# Product Change Notification

**Product Change Notification:** E-20-016724**PCN Date:** 27-NOV-20**Customer:** TTI, Inc. ( 1305175 )**Location:** Maisach-gernlinden**Agreement:** TTI001

C-1103032 HD.64.Sti.C, C-1103033 HD.64.Bu.C, C-1103112 HN.D.64.Sti.C, C-1103113 HN.D.64.Bu.C

| 2-1103112-3                            |  | HN.D.64.Sti.C  |  | HD-064 MALE INSERT FOR MACHINED CONTACT TYPE<br>HD-064 公插, 车削针型 (HTS) |  |

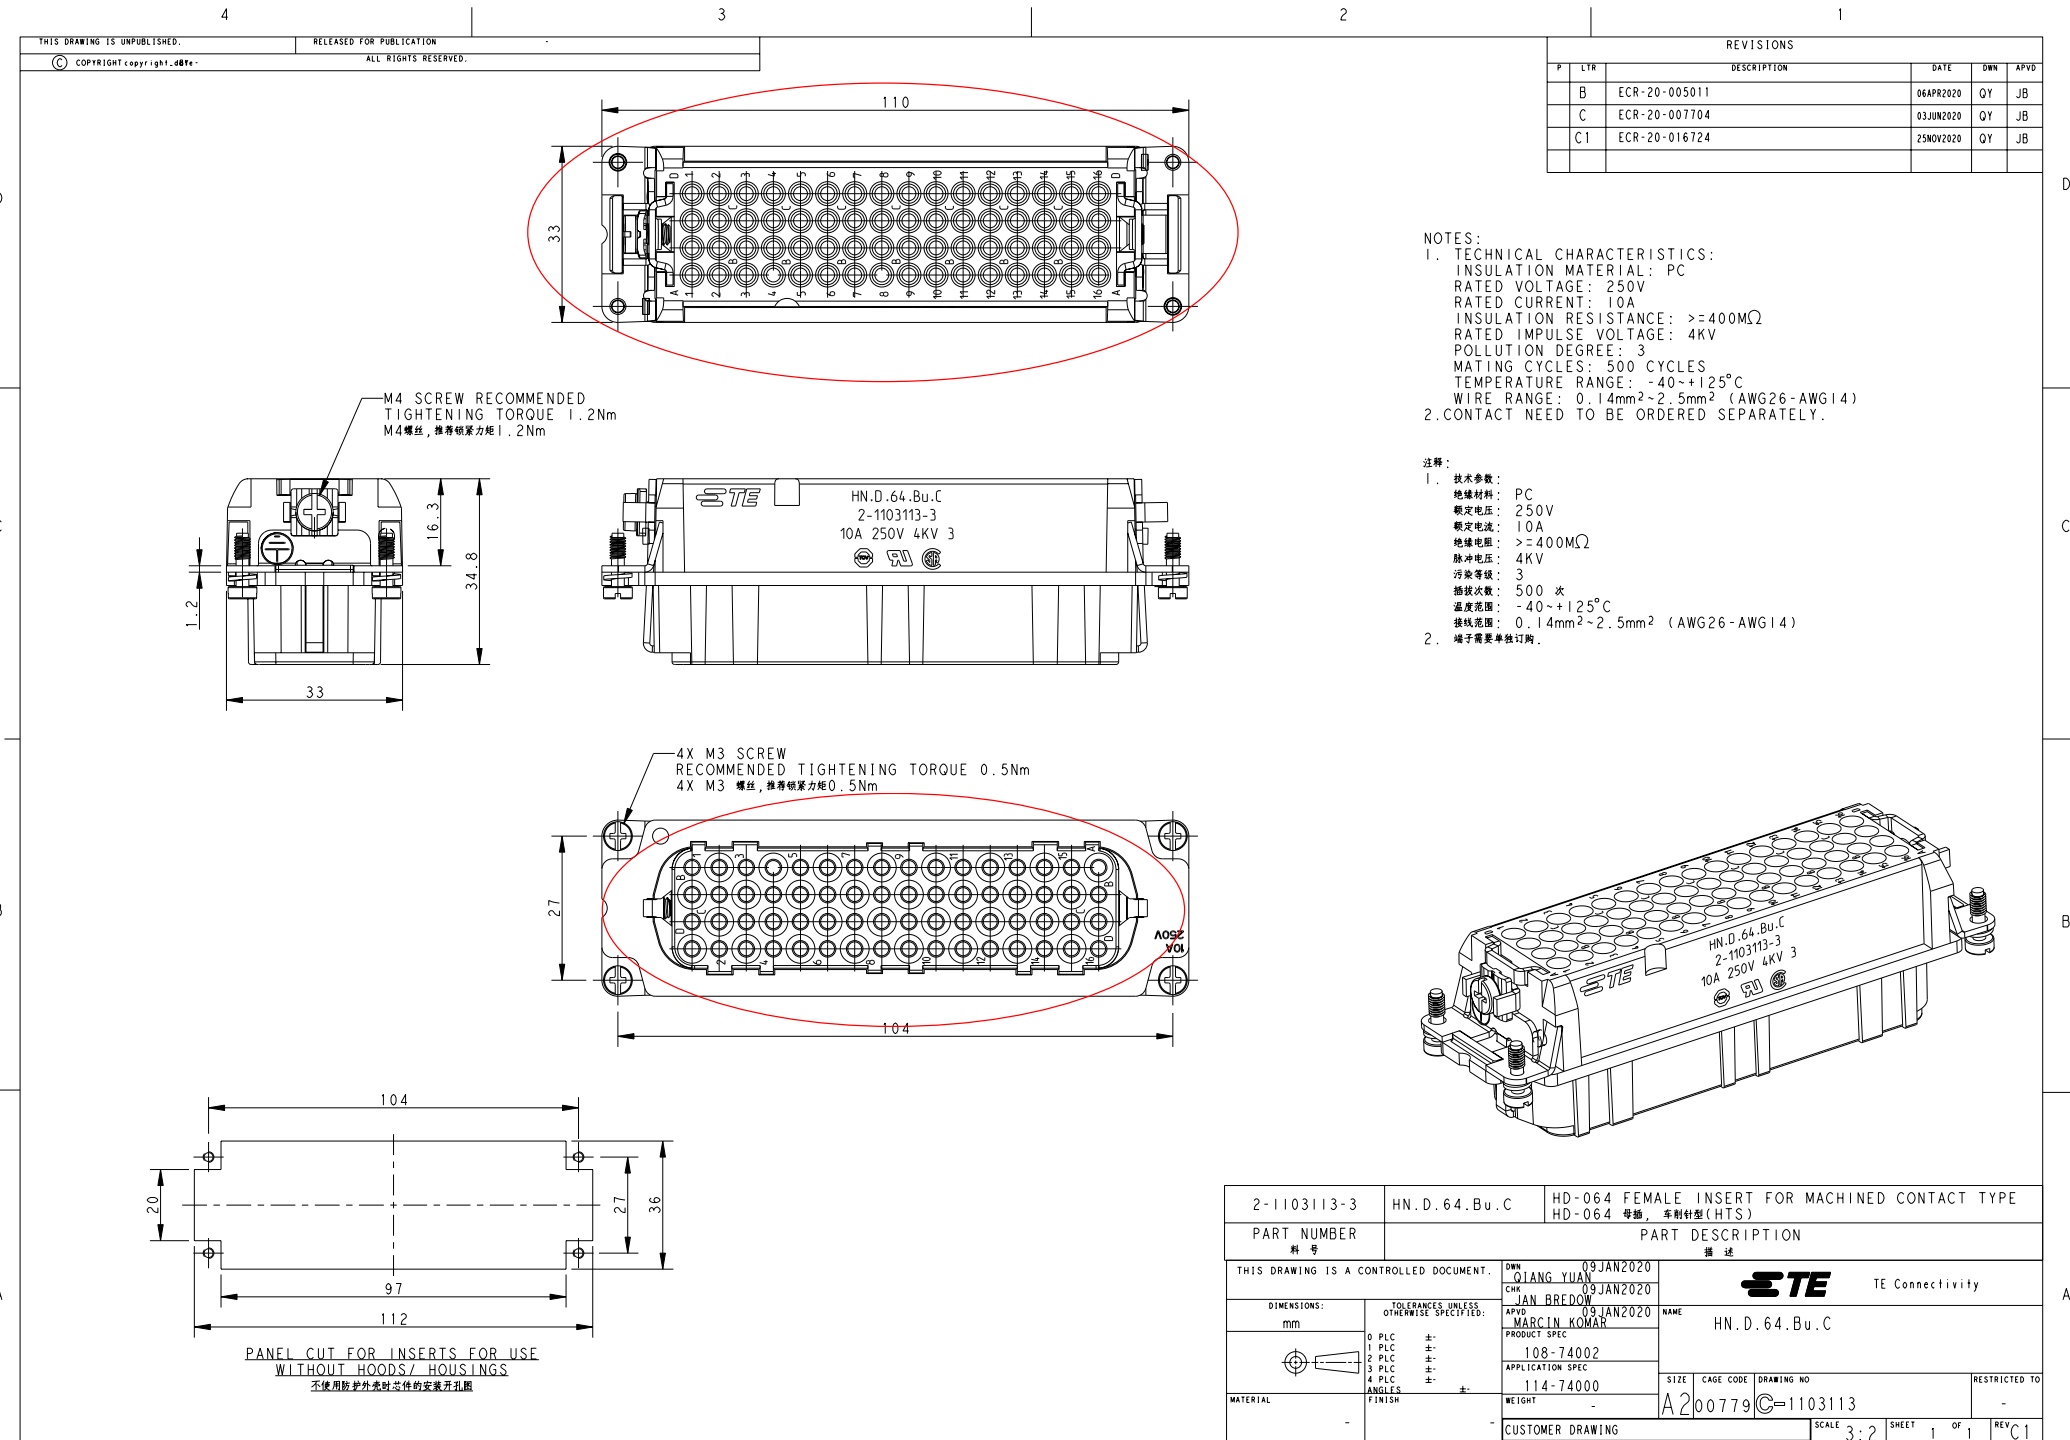
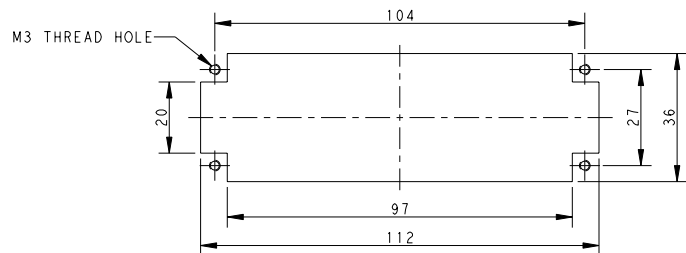
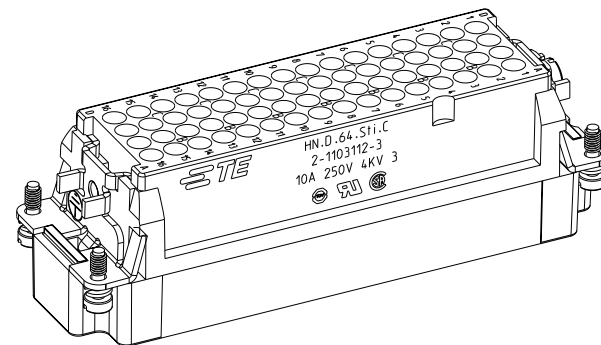
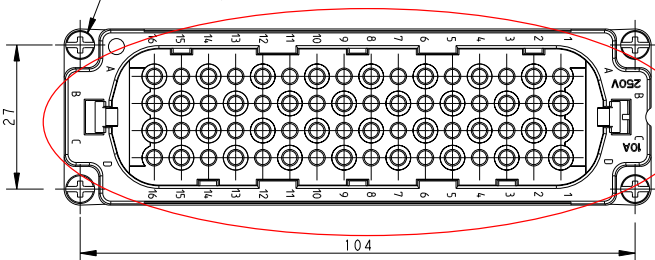
Dear Customer, please be informed that we adjusted our internal drawings documentation and added mark B and C for description of the pin column. The descriptions mark B and C there are currently visible on the drawings approved by you in the last PCN - E-20-007704. This will not affect any functionality of our products and this is only internal drawings clarification. Thank you for understanding.

| P  | LTR | DESCRIPTION   | DATE      | DWN | APVD |
|----|-----|---------------|-----------|-----|------|
| C1 |     | ECR-20-016724 | 25NOV2020 | QY  | JB   |

| 2-1103032-3   |  | HD.64.Sti.C  | HD-064 MALE INSERT FOR STAMPED CONTACT TYPE<br>HD-064 公插, 冲压针型 (HTS) |  |

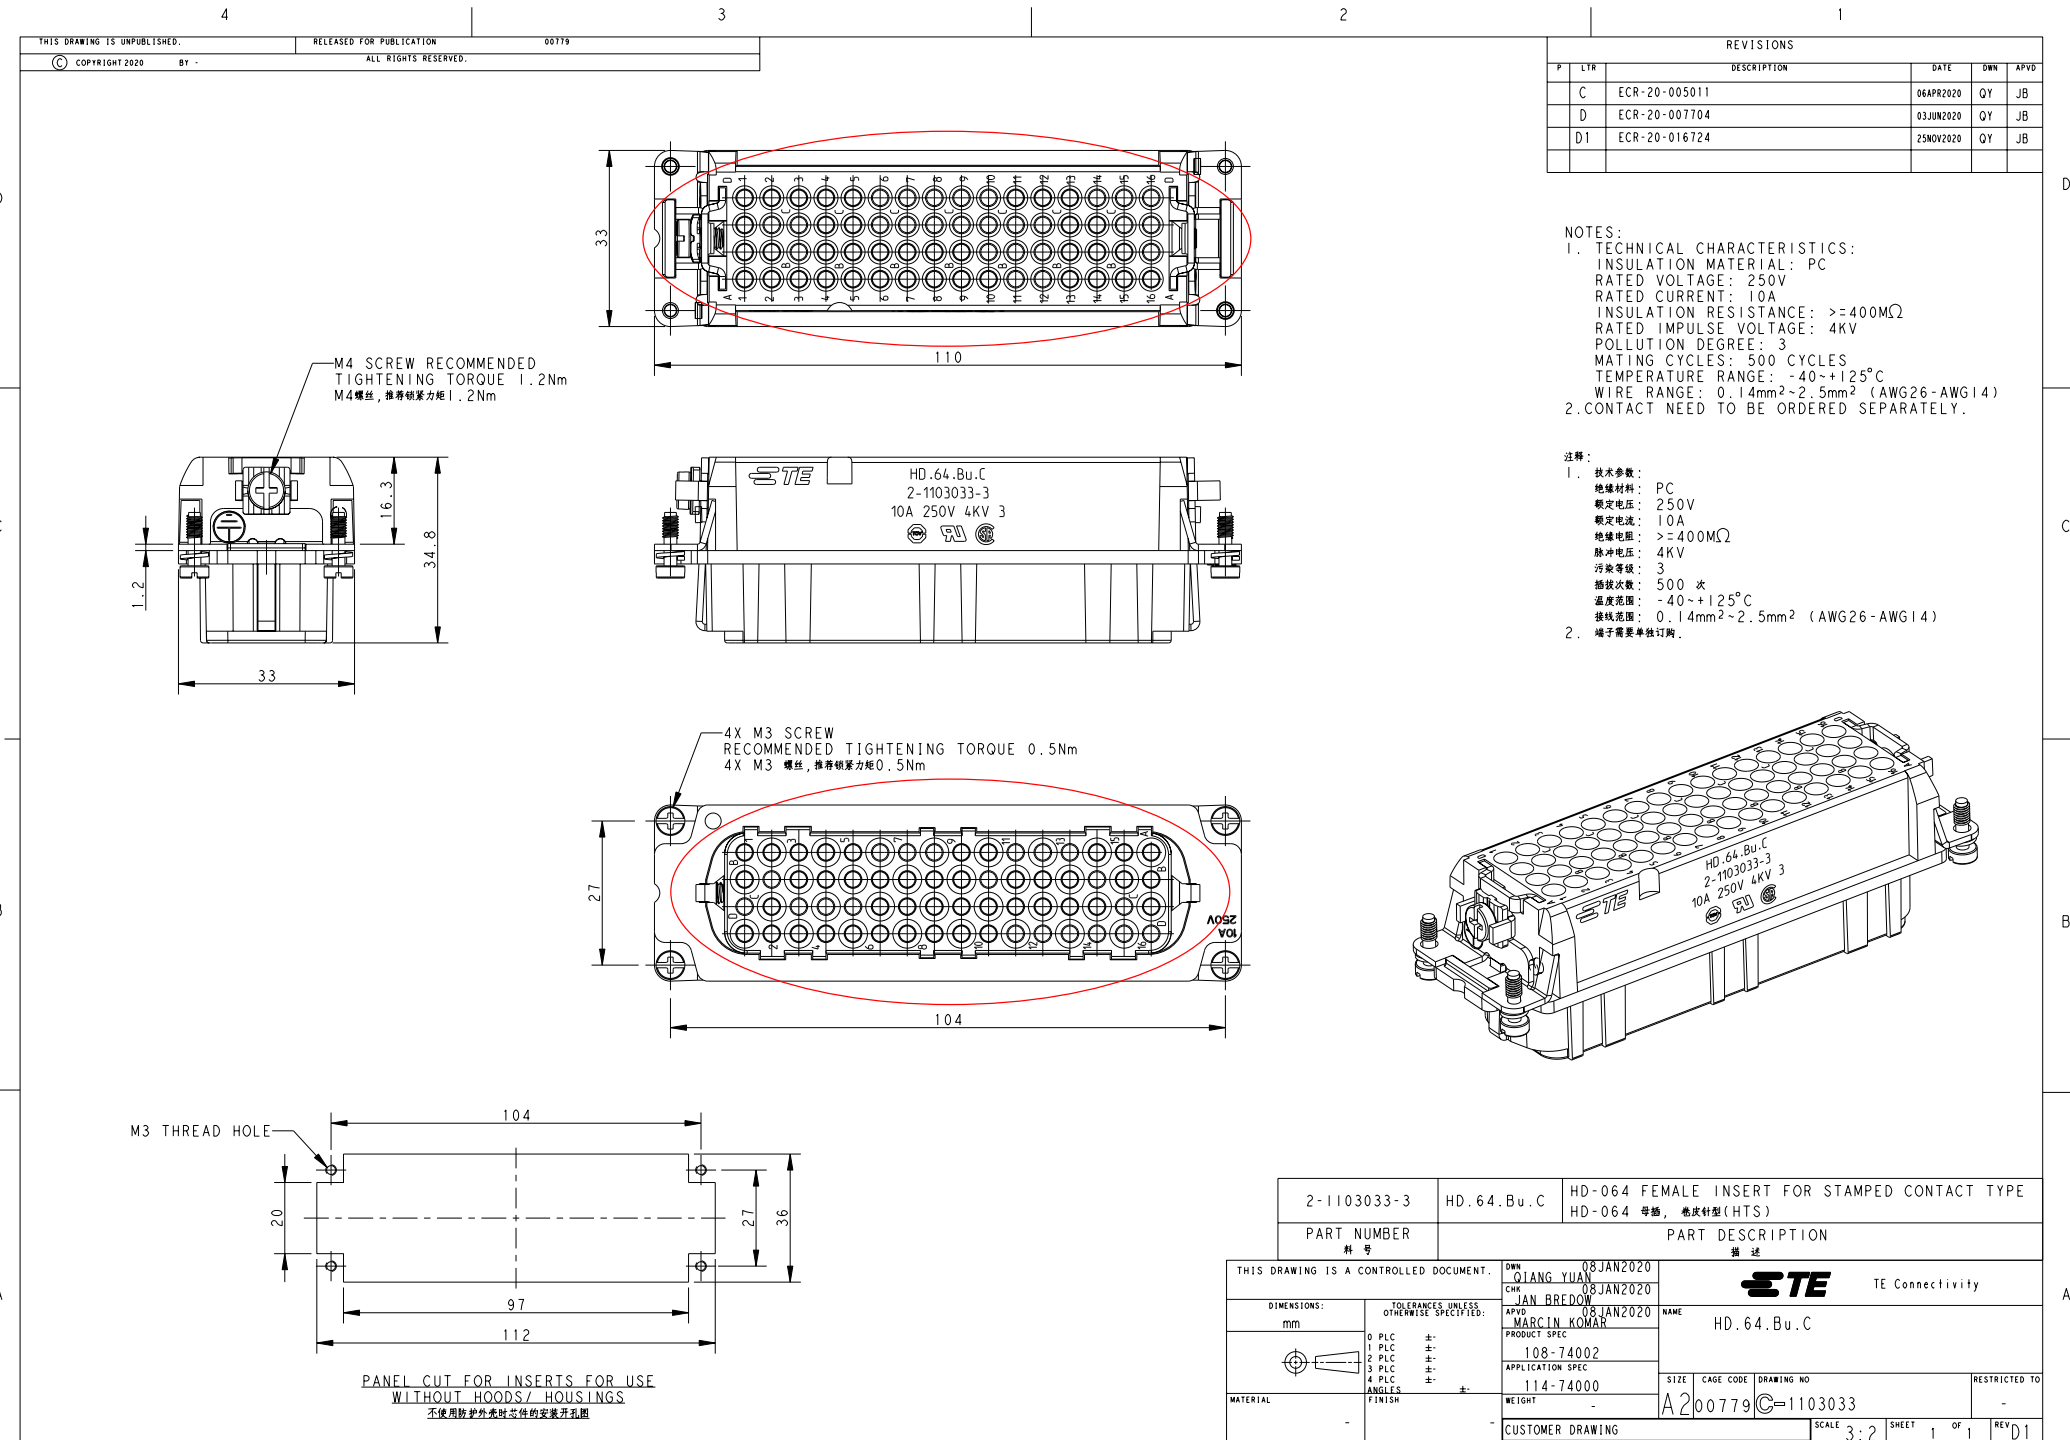
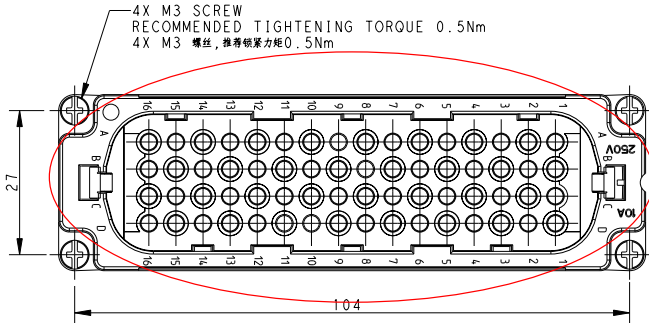
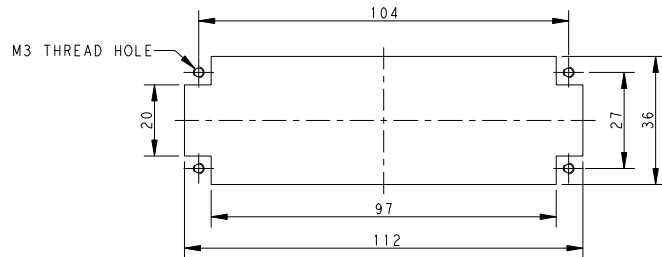
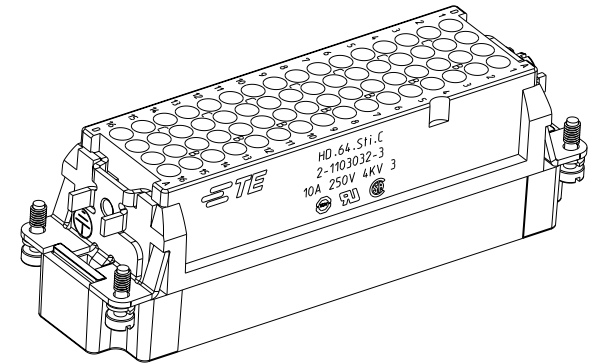
| REVISIONS |     |               |           |     |      |
|-----------|-----|---------------|-----------|-----|------|
| D1        |     | ECR-20-016724 | 25NOV2020 | QY  | JB   |
